**Minutes of the Pre-bid Meeting held on April 12, 2017 at 11.00 AM at Cochin SEZ Administrative Building,  
Kakkanad, Cochin**

**Design, Engineering, Supply, Installation, Testing, Commissioning and Operation & Maintenance (O&M) for  
5 Years of Zero Liquid Discharge (ZLD) System with Reverse Osmosis (RO) including Reject Management  
for Common Effluent Treatment Plant (CETP) in Cochin Special Economic Zone (CSEZ), Kakkanad, Cochin**

**NIT No.: WAP/H-3082/CSEZ/IWMS/ZLD/2017 dated the April 03, 2017**

## Annexure – 2: Layout of Existing CETP

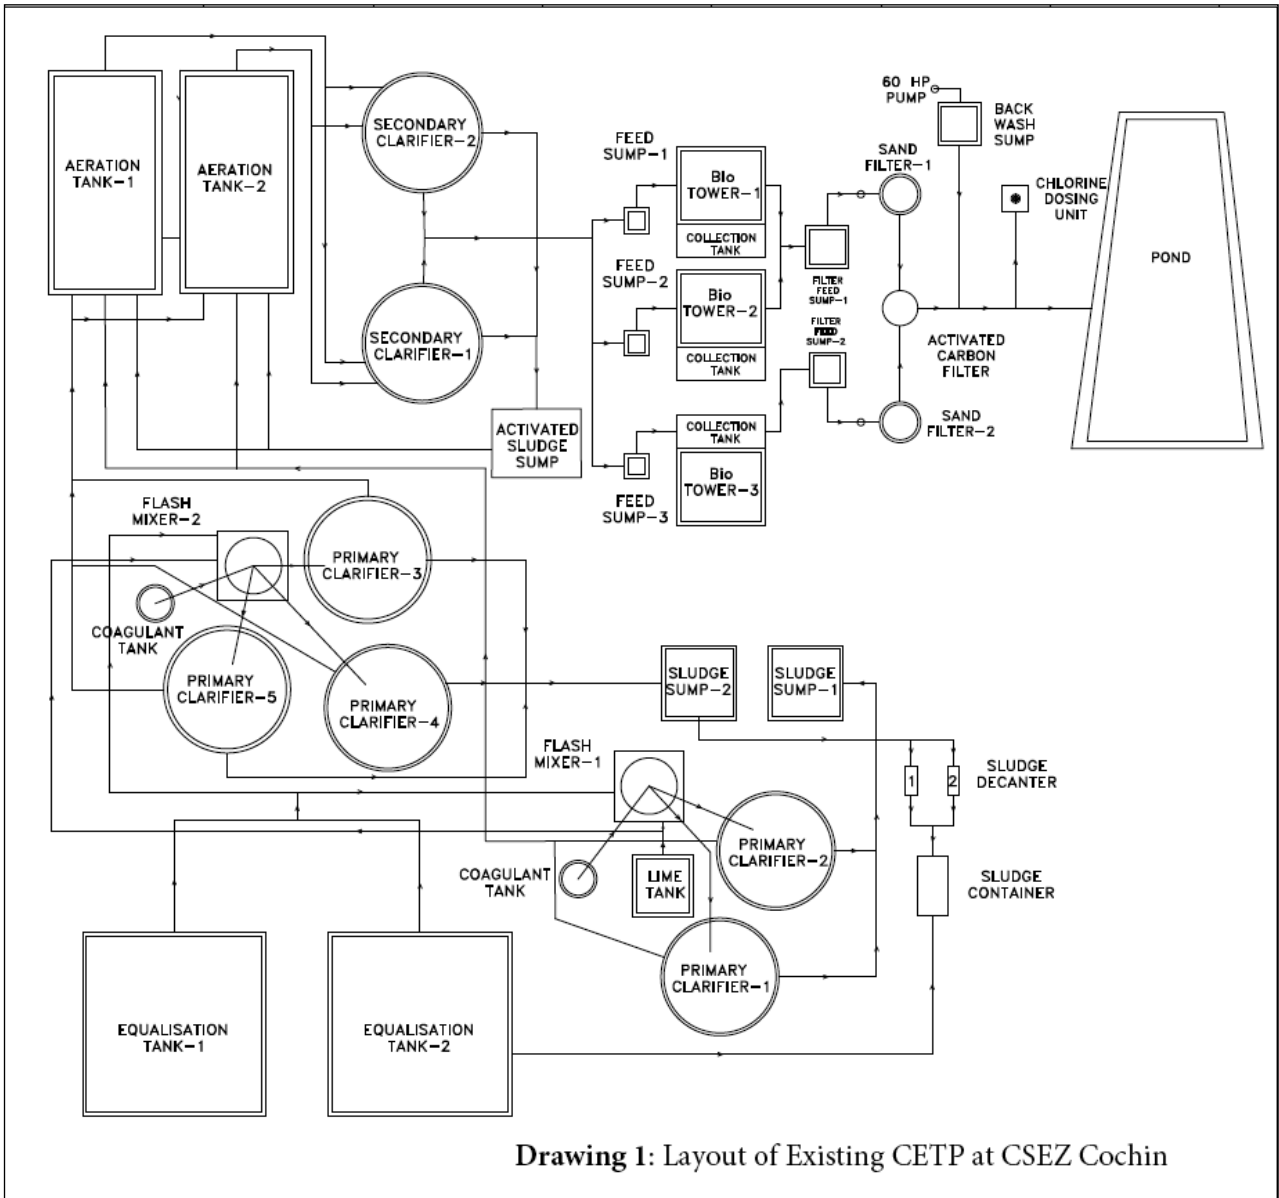
16		Please provide the Treatment Scheme in the Existing ETP	Please refer Annexure – 2.
